Annex M1 – Summary of Key Findings and Recommendations during the Monthly Site Audits

Central Police Station

Schedule of Character Defining Elements

Photograph taken on 22nd August 2013 by the Management Contractor, showing the granite border at the west archway.

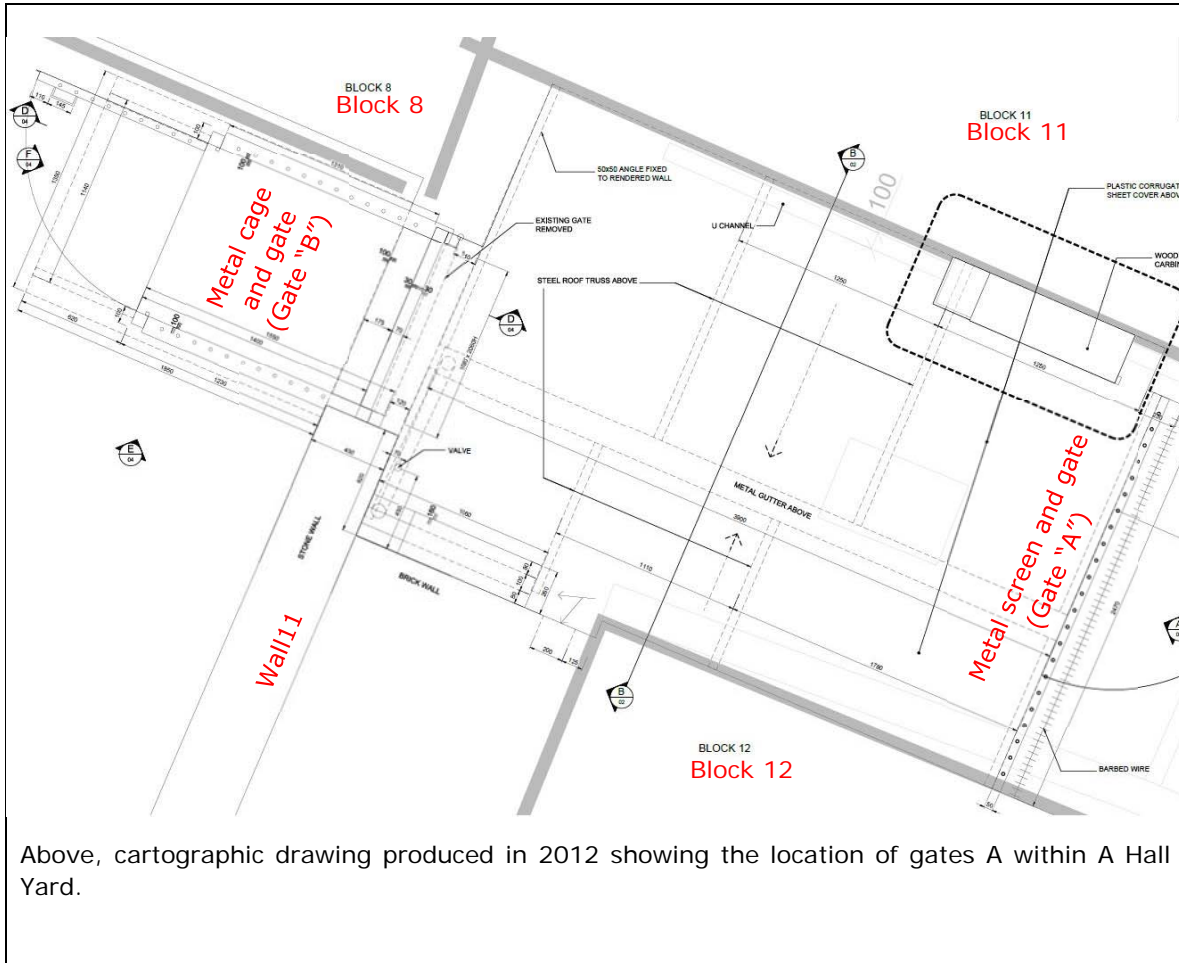
1. Exhaust all measures to identify and locate all the granite flagstones from this area, collect the photographic record from the Contractor who lifted up the granite flagstones, lift up the granite flagstones that have been laid incorrectly, carry out a dry lay invite conservation architect for inspection, and finally lay the granite flagstones in accordance with contract documents and specifications. All the above works to be carried out at neutral cost to the contract.
2. Review and revise the work practices of the works package contractors especially the handover process of materials between different works package contractors.
3. Supervise the work operations to ensure compliance with the Contract Documents.
